Traffic Impact Assessment

UNE Tamworth Central Campus

Prepared for Architectus / 23 October 2024

1.0 Response to Submission

Figure 1.1: Average Weekday Car Space Utilisation (Mon-Fri)

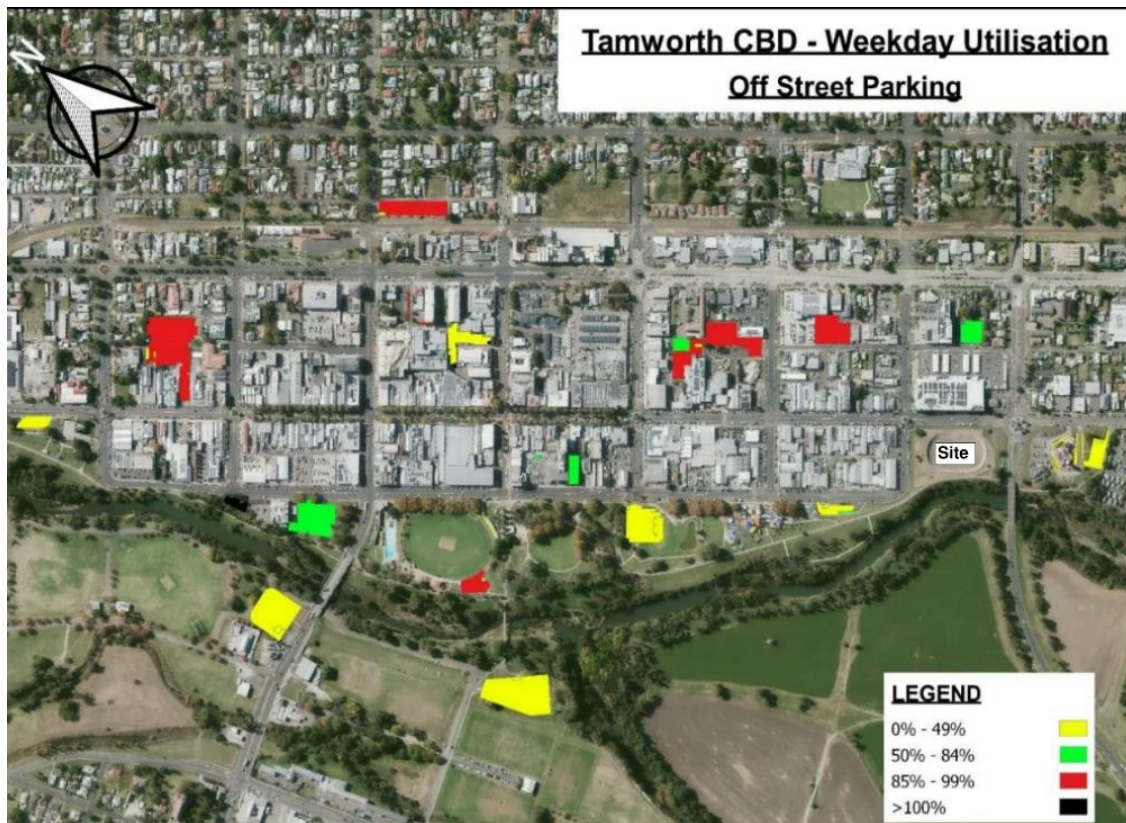
- *Justification for reliance on on-street parking availability*

As outlined in the comparative data response, the development proposes utilising on-street parking adjacent to the site, considering the ample parking available in the Tamworth CBD. A review of Tamworth Regional Council's parking strategy has been completed for the adjacent parking areas.

The figures below illustrate the current utilisation levels of both on-street parking and nearby parking facilities, demonstrating sufficient capacity to accommodate the proposed on-street spaces. Parking availability on Peel Street adjacent to the site is noted at a low utilisation of 0-49% (refer Figure 1.1).

Off street parking areas at Peel Street adjacent to the Country Music Hall of Fame, on Kable Avenue and adjacent to Bicentennial Park is also noted as 0-49% utilisation (refer to Figure 1.2) all within 500m walk of the site. Additional parking is available at Byrnes Avenue (noted as 50-84% utilisation).

Figure 4.2: Off-Street Car Parking

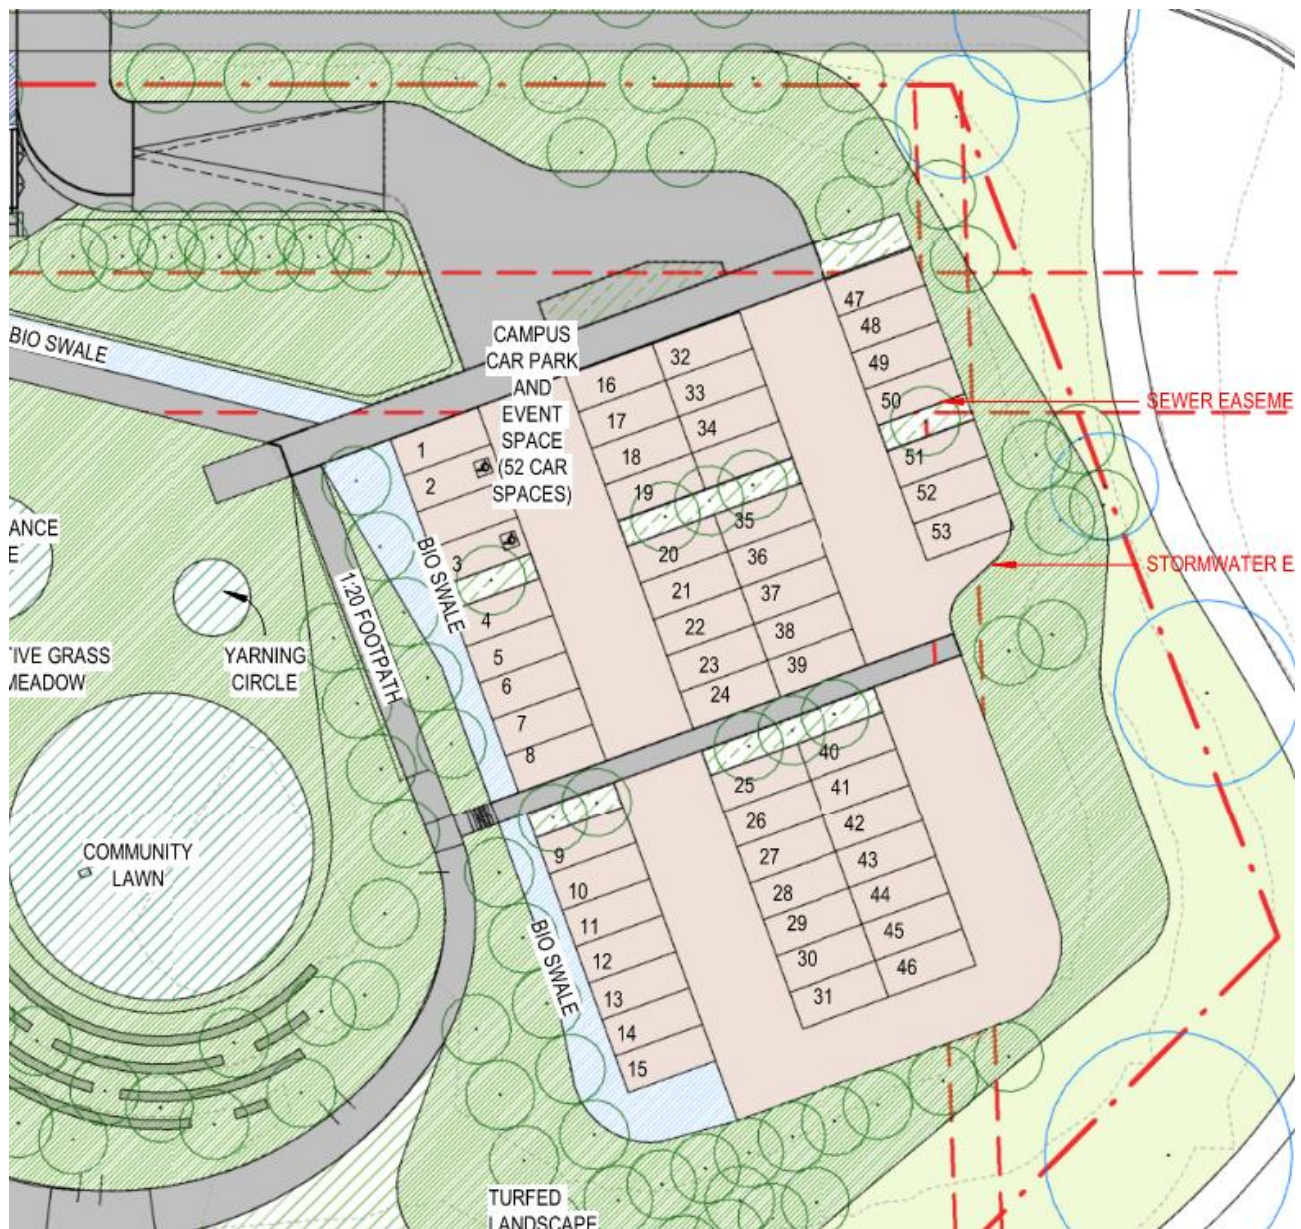
The proposed car parking arrangement and number of spaces is not considered appropriate for the use sought. The Tamworth Regional Development Control Plan 2010 (TRDCP) requires 1 space per 2 staff plus 1 space per 5 students for higher education establishments.

Based on the presumed staff and student numbers as detailed within the Traffic Impact Assessment (31 staff and 266 students), the development would require 70 car parking spaces to be provided on site. The proposed 53 is not supported, and an updated plan with a minimum 70 spaces is to be provided. Council will not support the consideration of 33 available on street spaces to form an offset from the requirement to provide parking to cater for the use proposed.

Further, the carparking layout proposed does not meet the objectives outlined in AS2890.1, particularly with reference to the use of long blind aisles. The blind aisles will result in cars reversing in the event that they enter, only to find all bays are occupied, and no facility for turning. The carpark should be re-designed to accommodate the additional required bays, and provide proper circulation.

Two accessible parking spaces have been provided in the on-site car park, near the walkway connecting to the UNE building. Additionally, two more spaces have been relocated closer to the main entrance along Roderick Street – Refer to Section 4.2.1 and Section 4.2.2.

The campus contains on-grade car parking providing 53 parking spaces on-site. All on-site parking is proposed to be paid parking. Visitor, student, and staff parking will operate under a permit system, similar to UNE Armidale Campus. These permits will not be restricted and can be obtained for shorter term parking if required.

Figure 4.3: On-Street Parking

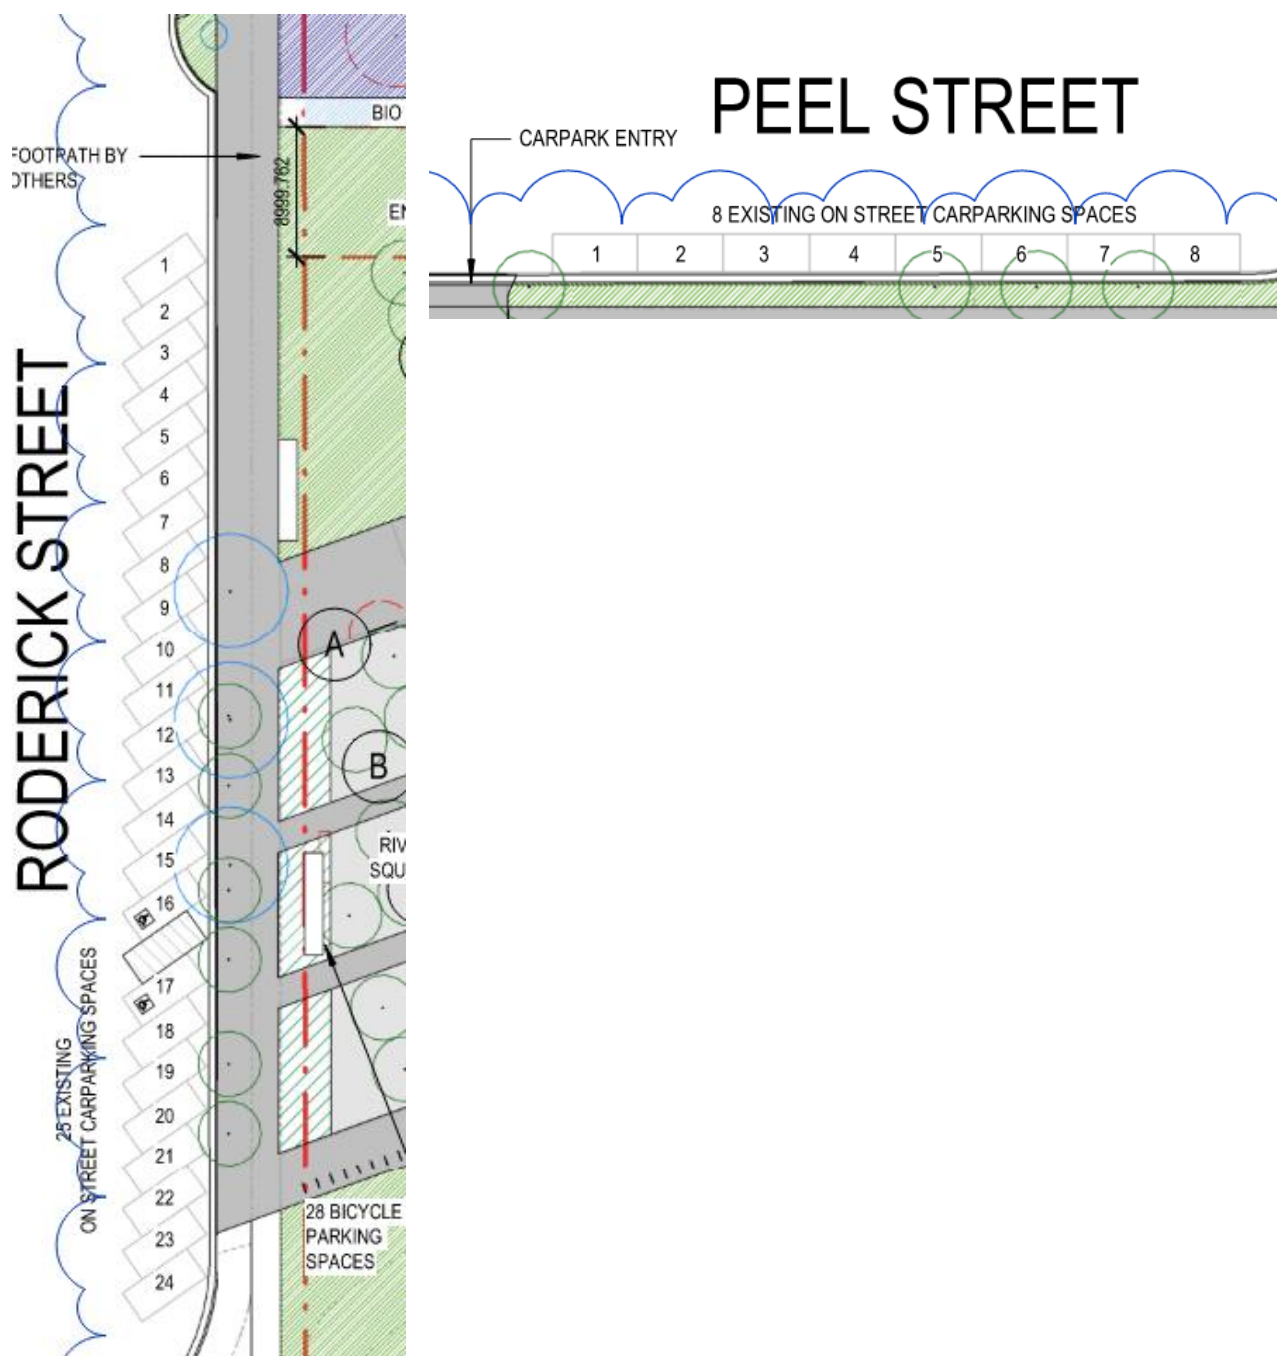
- *Opportunities to relocate parking for people with disabilities closer to the building*

Outside the main campus entry, on-street parking is widely available on Roderick Street, with 45-degree angled parking available on one side of the road for the majority of the road length and parallel parking on the other side of the road. A total of 24 existing angled parking spaces are to be retained on Roderick Street to the eastern kerbside and a further 8 existing parallel parking spaces will be retained on Peel Street to the southern kerbside.

Figure 4.5: Service and Loading

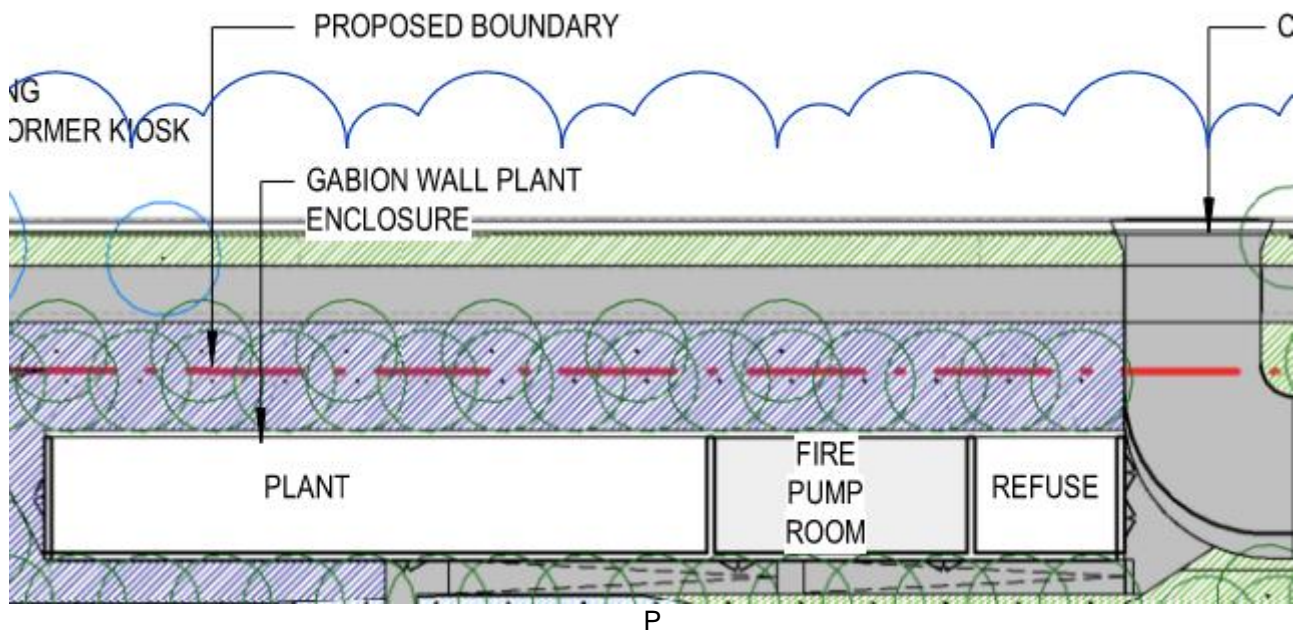
The design does not facilitate any separation of passenger vehicles and commercial vehicles. The current vehicular access would be disrupted by waste collection and other service vehicle activity, and should be redesigned to allow for concurrent access and servicing to occur. It is also noted that no marked delivery/set down/drop off areas are shown on plans where all three elements would be expected to occur with an educational establishment.

Service and loading vehicles will access the site through the vehicle access point connected to Peel Street. To efficiently manage waste disposal, dedicated waste facilities will be positioned to the north-west of the premises. The largest anticipated vehicle will be a medium rigid vehicle, primarily employed for on-site operations and waste collection purposes.

Figure 4.8: Undercover Bicycle Parking

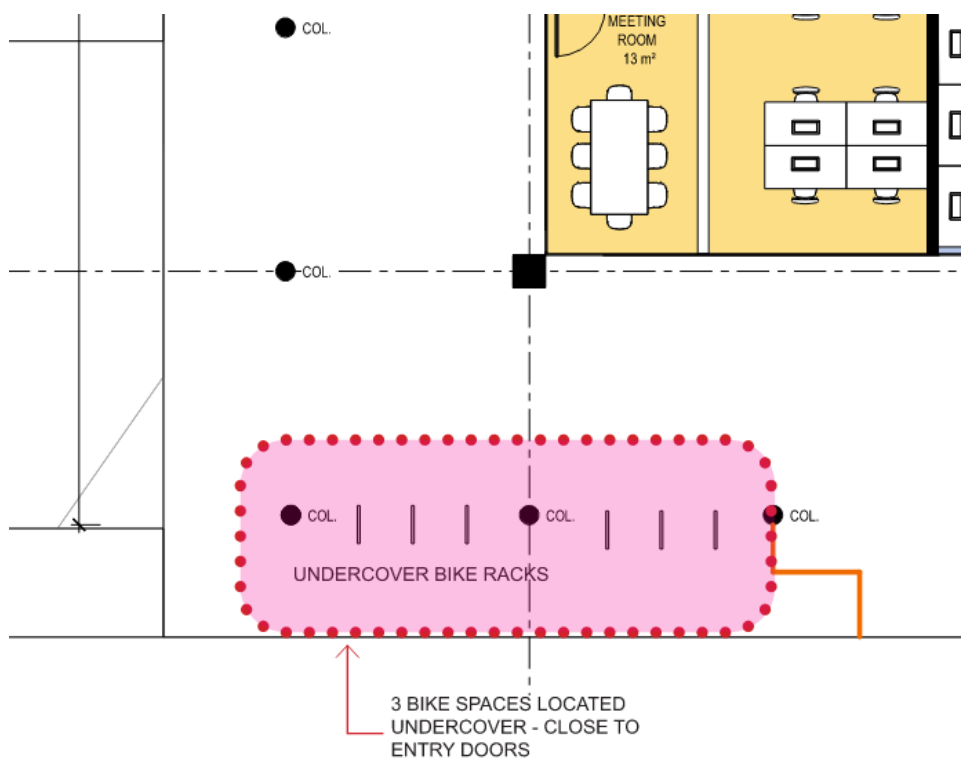
- *Location and number of proposed bicycle parking spaces*

A total of 31 bicycle parking spaces are proposed. Of these, 28 spaces will be accessible from Roderick Street, with an additional 3 undercover spaces provided on the ground level near the entry door - Refer to Section 4.6

On-site cyclist facilities are available to ensure secure storage of bicycles and equipment. A total of 28 bicycle parking spaces is proposed that can be accessed from Roderick Street, along with an additional 3 undercover spaces located on the ground level near the entry door, as shown in Figure 4.7. and Figure 4.8.
